**City of Poughkeepsie
Planning Board
Meeting Agenda**

**RE: 47 Cannon Street
Planning Board File #2021-056**

SITE PLAN SUBMISSION SET
PROPOSED MIX USE DEVELOPMENT
47 CANNON STREET
CITY OF POUGHKEEPSIE,
DUTCHESS COUNTY, NEW YORK STATE
TAX MAP ID#:6162-77-086045

SITE PLAN

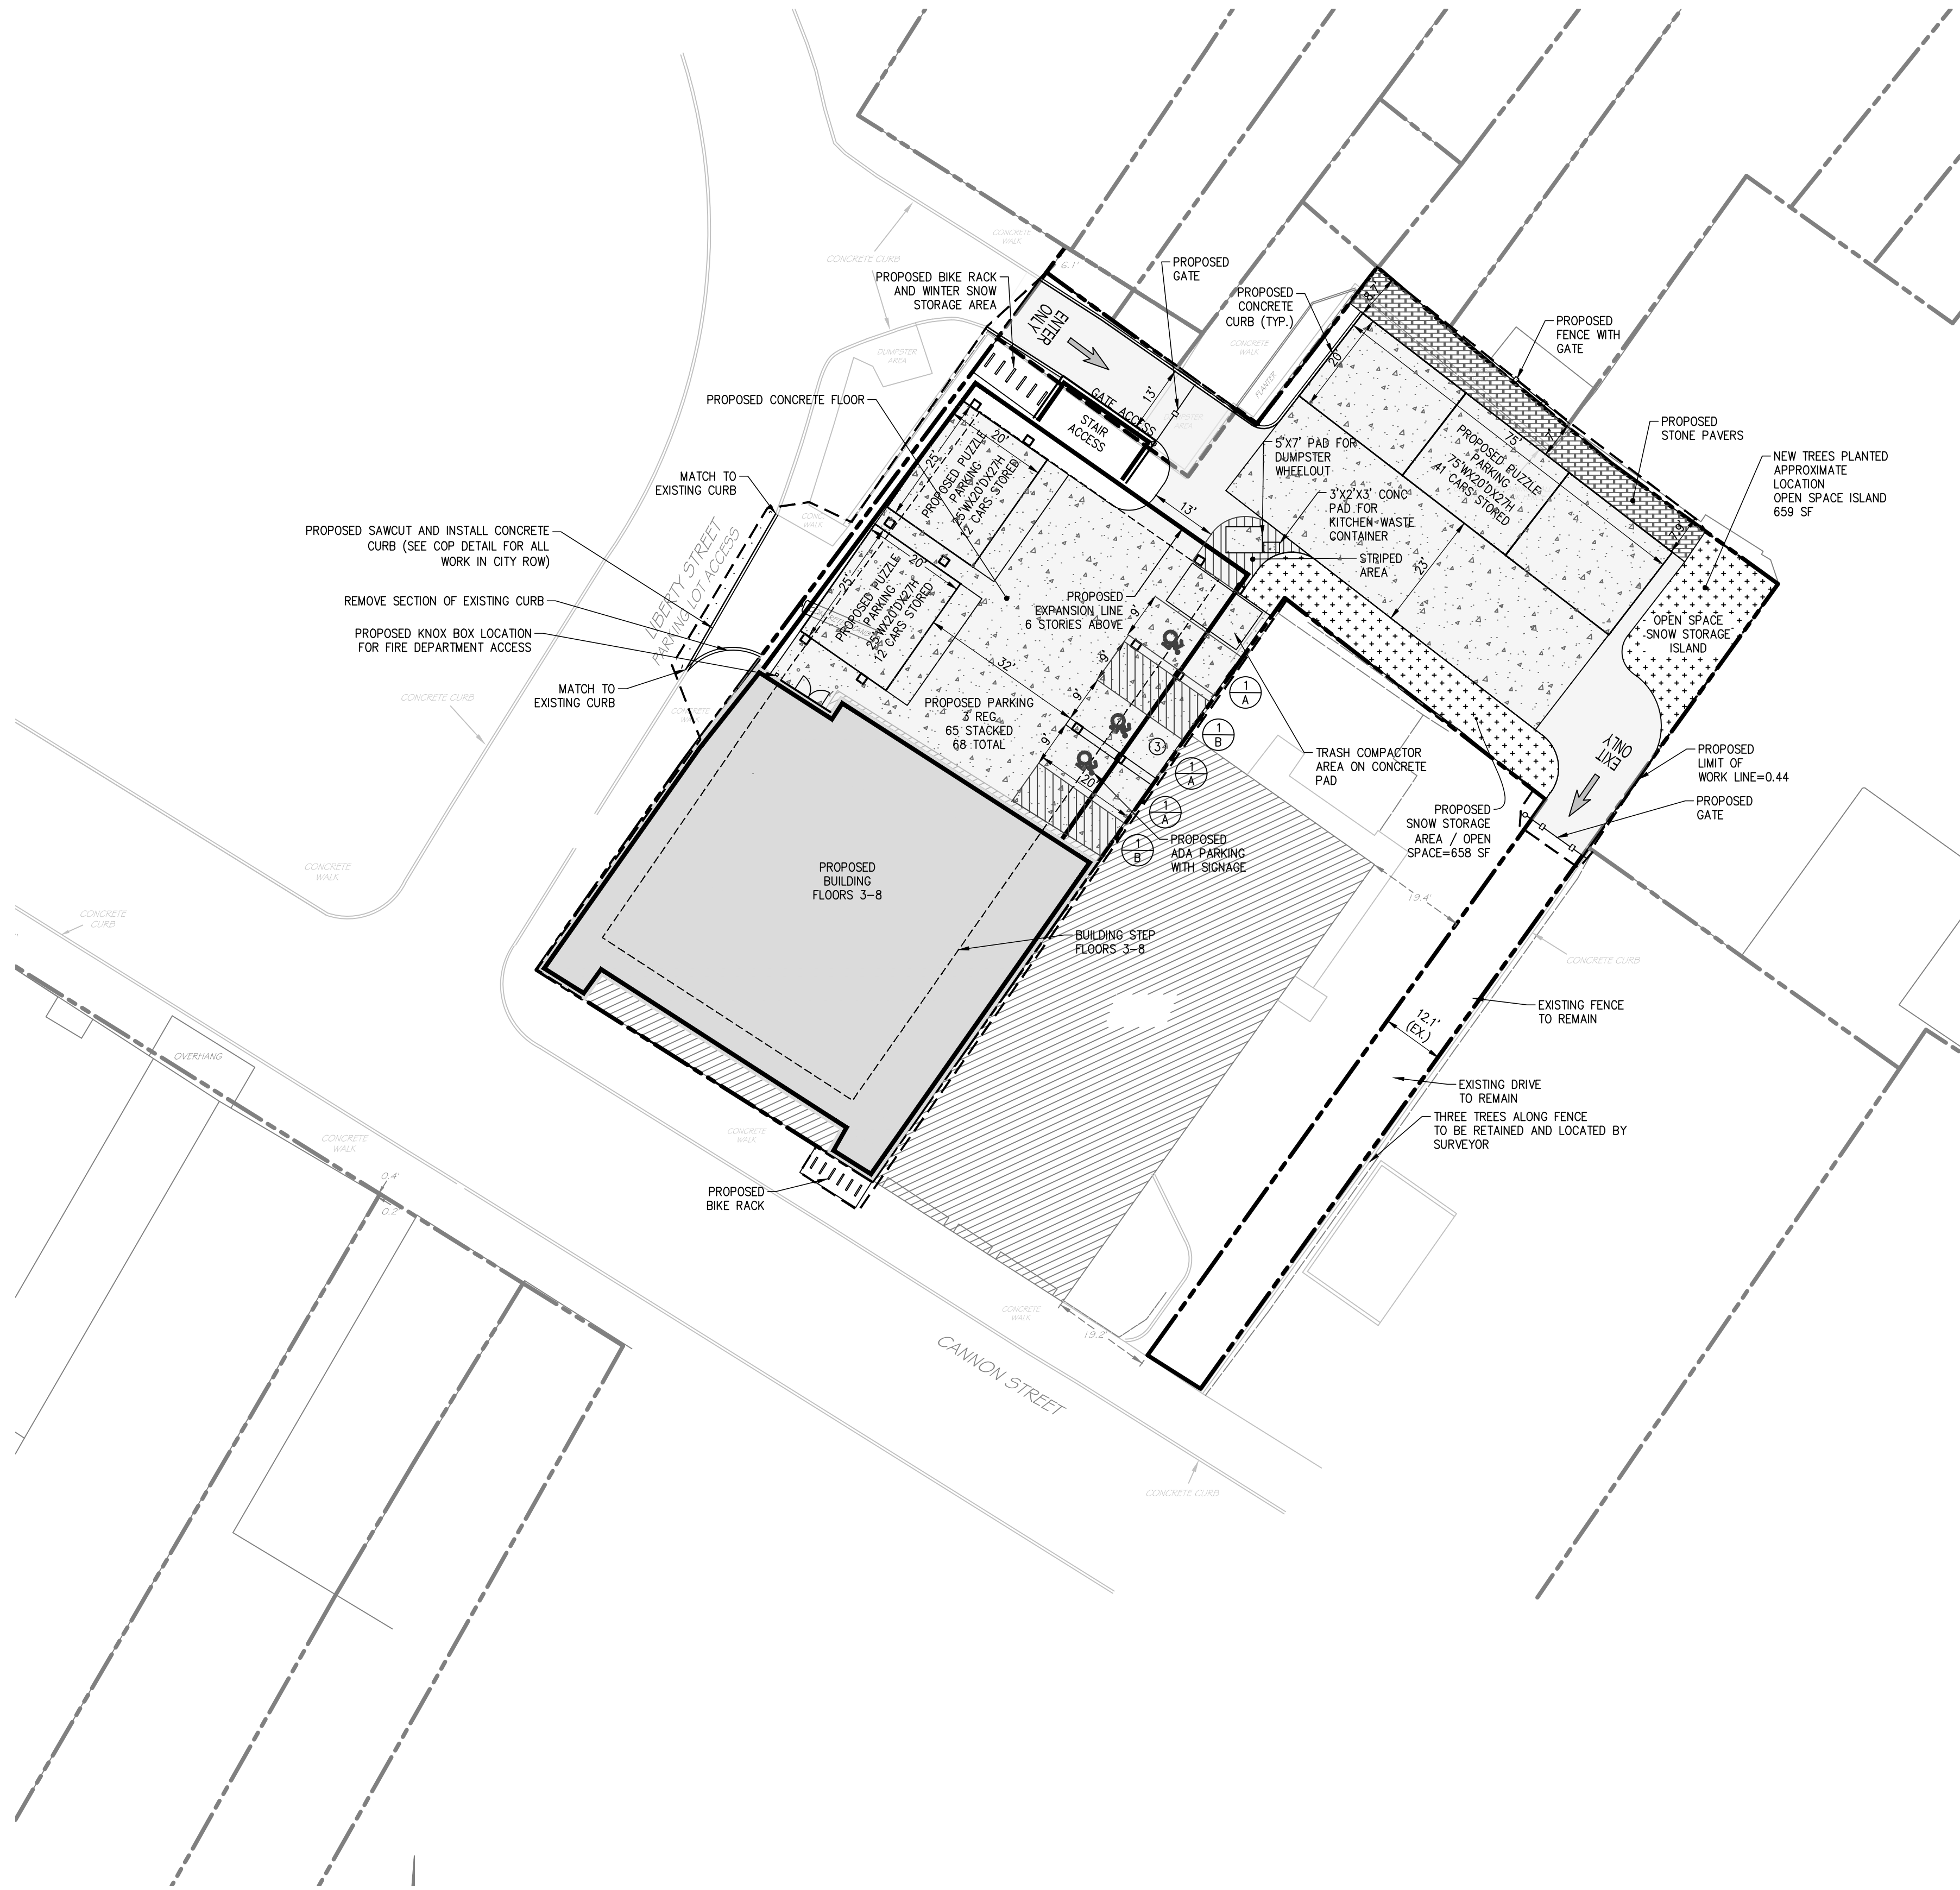
2. Section 19-3.37, Table 3.37(2)(d) requires that a minimum of 2875 square feet of open space be provided (15% of the total lot area). Section 19-3.37 Table 3.37-2 Footnote #2 allows green roofs to be counted towards open space requirements. While the revised plans claim adequate open space on the roof, design of the common open space located on the roof must be provided so that realistic calculations can be made, particularly given the irregular shape of the area and the intrusion of HVAC equipment and other utilities and areas labeled as "pitch down;"

3. Section 19-3.37 Table 3.37-4 requires that a total of 80 spaces (there is a possibility that the Planning Board could provide a different parking total for the restaurant and artisanal manufacturing facility, since it is more of a hybrid use where the parking requirement would be not as intense as it would be for a restaurant). Please note that:
 - a. It appears that either 67 or 108 spaces are claimed (Proposed "Puzzle Parking" has a note that claims 41 cars can be parked, while there is a note on within the footprint of the building that says "Proposed parking 1 Reg 65 Stacked 67 total). It is not clear if these notes are exclusive of each other, nor is it clear what is meant by "stacked" parking. Clarification of parking arrangement must be provided.

5. Section 19-3.37(13)(g)(2)(viii) requires that parking lots should provide open lawn areas to accommodate snow storage. A snow storage area is now shown, though it is not a lawn area, as it overlays a bicycle storage area. It is not clear this area will be adequate; and,

Response: Open space calculations are based off the following items. In the proposed parking area there is a total of 1,371 SF of open space. Per sheet SK103, eighth Floor and Roof Plan schematics, the rooftop has an open space of 3,202 SF for a total of 4,519 SF which exceeds the required per city code of 2,875 SF.

LRC Response: the parking provided has been clarified. Per the Site Plan sheet SP-1 the parking is described as follows:

LRC Response: Proposed snow storage areas have been identified on the site plan sheet that are adjacent to puzzle area in the parking lot.

LRC Response: The proposed refuse removal calls for a dumpster to be rolled out to the striped area. The dumpster area at the north is existing and is not on the subject property. Additionally, for clarity the puzzle parking area is setback at 7' from the property, line. Dimension have been added for clarity. The removal the kitchen waste will be accommodated with for a container located on a 3'x2'x3. Concrete pad located near the dumpster pad.
